## **FINAL ENVIRONMENTAL IMPACT REPORT - Appendices**

### **WILMINGTON-HARBOR CITY COMMUNITY PLAN AREA**

## **Ponte Vista Project**

Comment Letters on the Draft EIR

**FIGURE 1**  
**Ponte Vista Project**  
**Sewer Map**

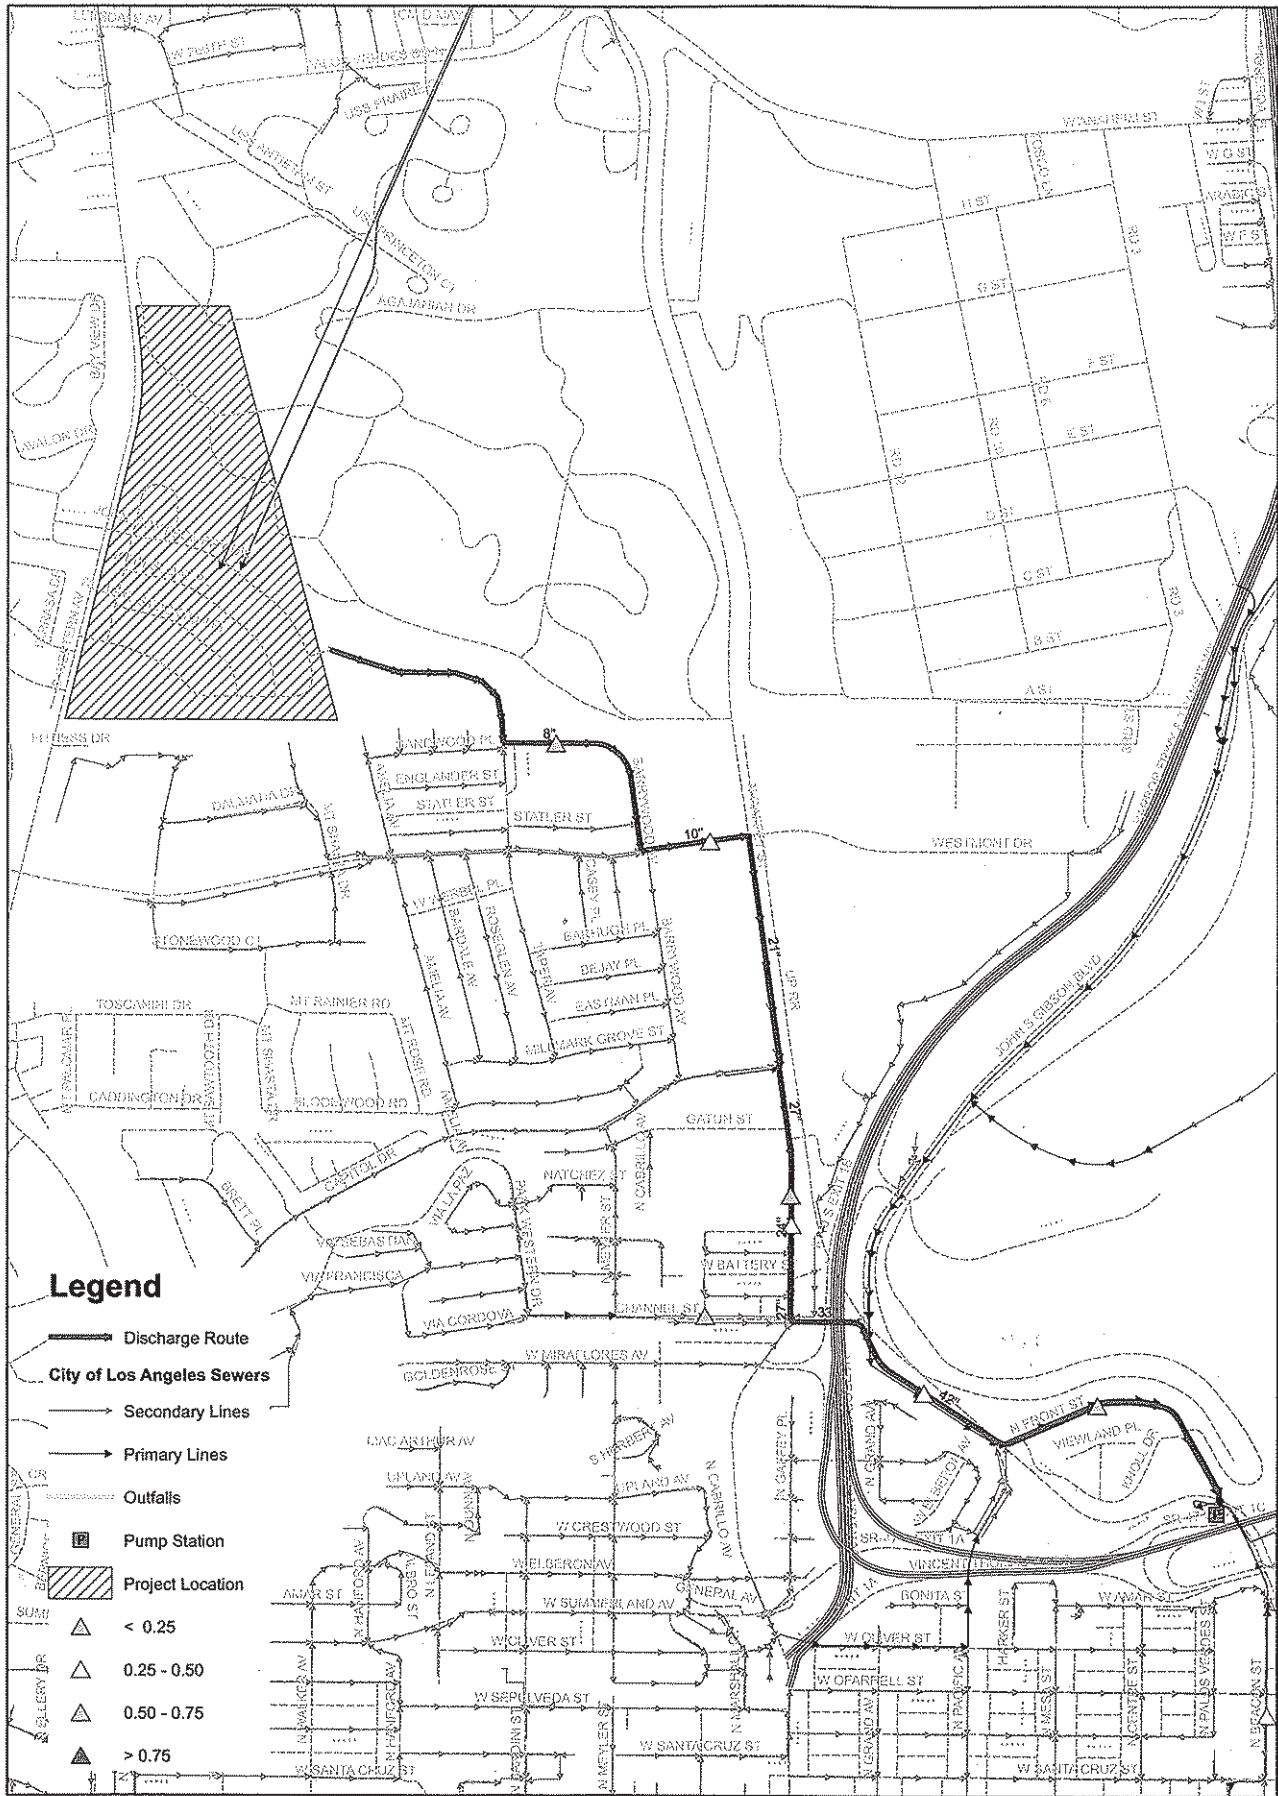
The sewer infrastructure in the vicinity of the proposed project includes the existing 8-inch line on Taper Ave. The sewage from the existing line continues into an 8-inch line on Sandwood Pl, 10-inch line on Westmont Dr, and 24-inch line on Gaffey St, before finally discharging into a 42-inch line on Pacific Ave. Figure 1 shows the details of the sewer system within the vicinity of the project.
